**RM03**

DISK DRIVE

PROCESSOR TYPE 10, 11, VAX

Engineering Change  
Order Log

Figure 1. OLD Non-keyed AC Power Cord (VDE)

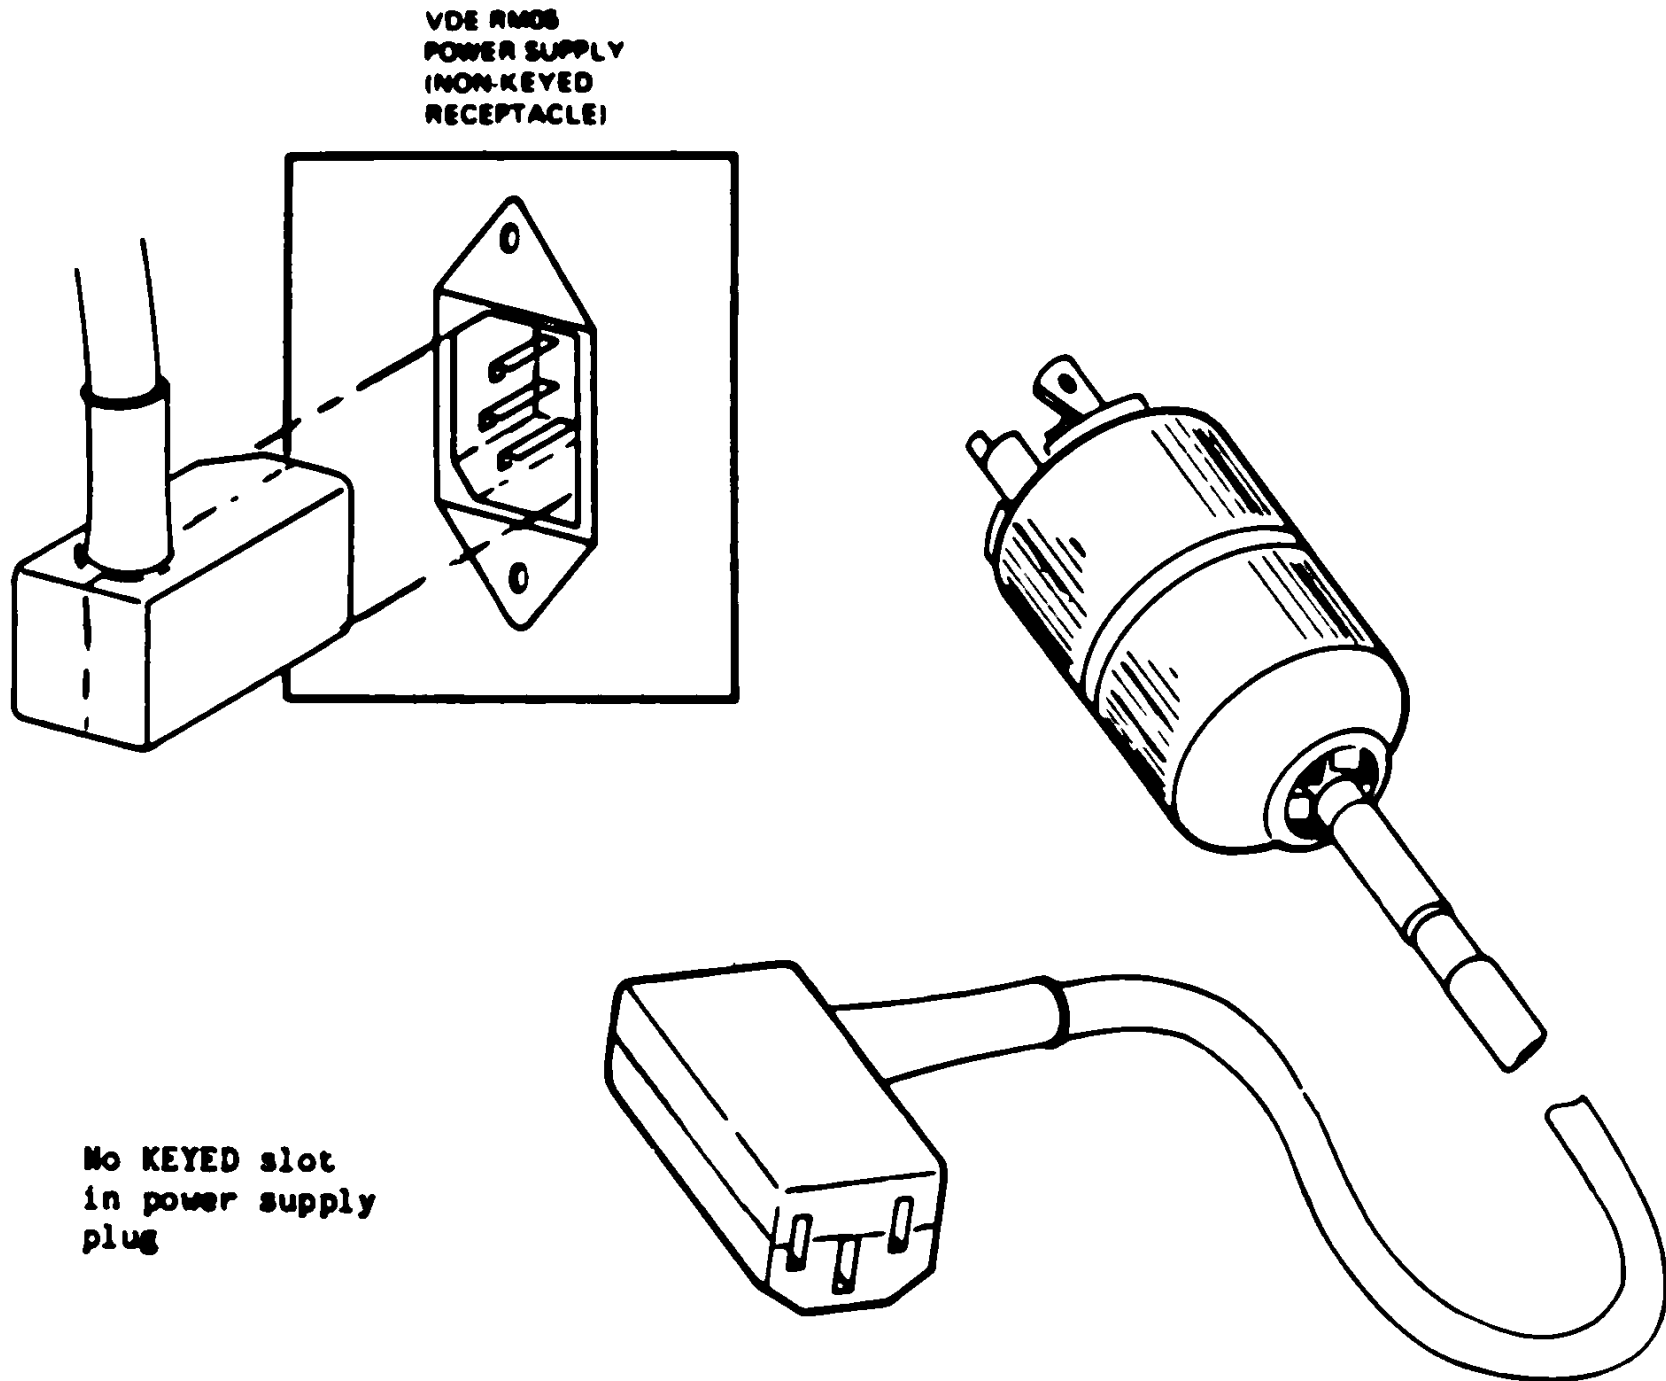
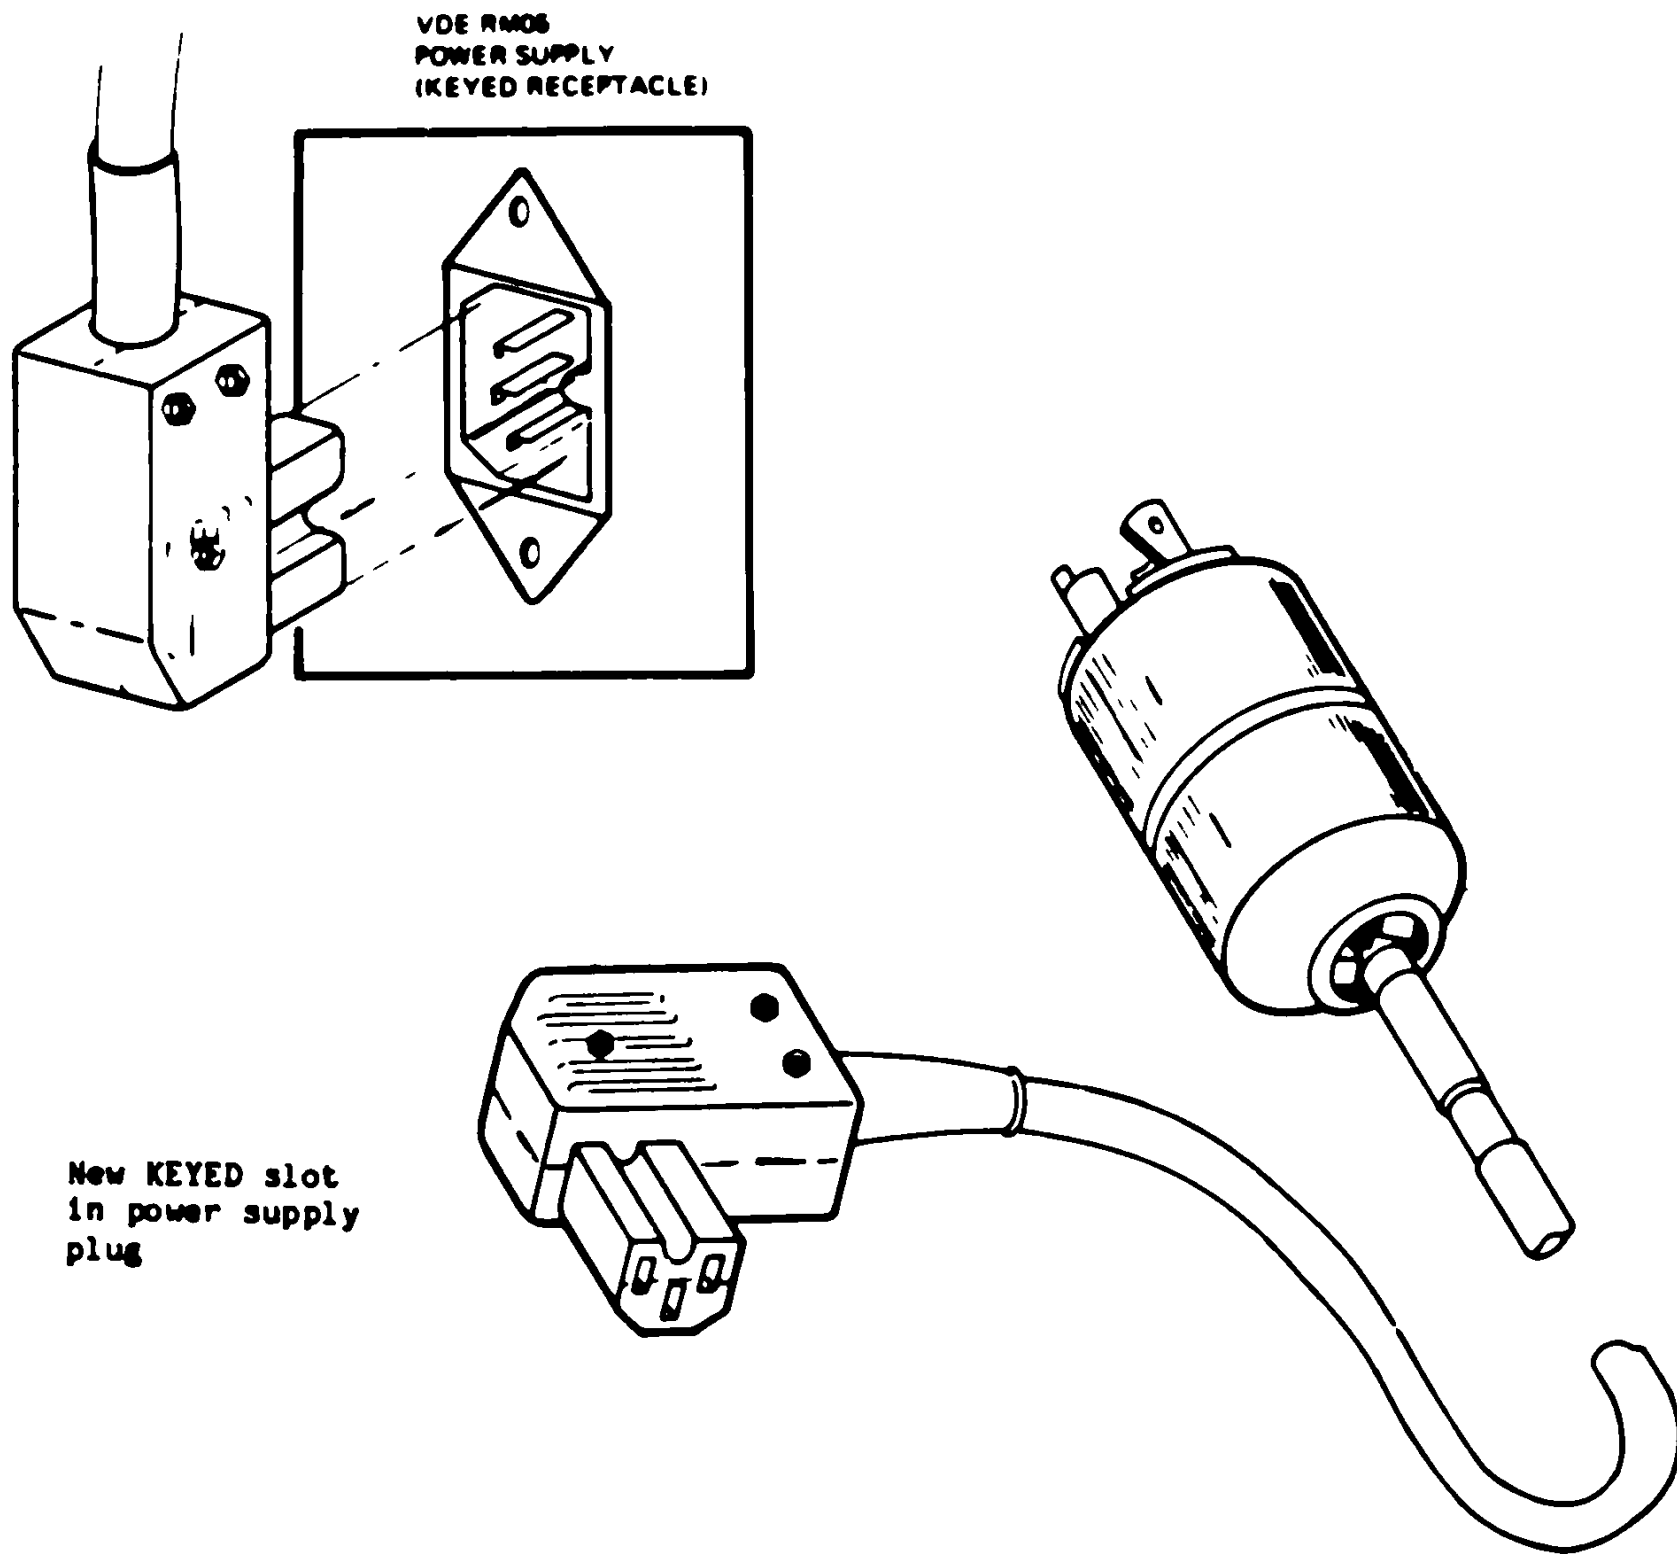
RM05 drives have started shipping with higher revision VDE power supplies using new "keyed" AC power cords to further meet VDE requirements. The new keyed power cords are compatible with ALL VDE power supplies. However, drives previously installed in the field may contain an earlier non-keyed AC power cords which WILL NOT FIT INTO the new VDE power supplies. Figure 1 and Figure 2 illustrate the physical differences between the keyed and non-keyed cables.
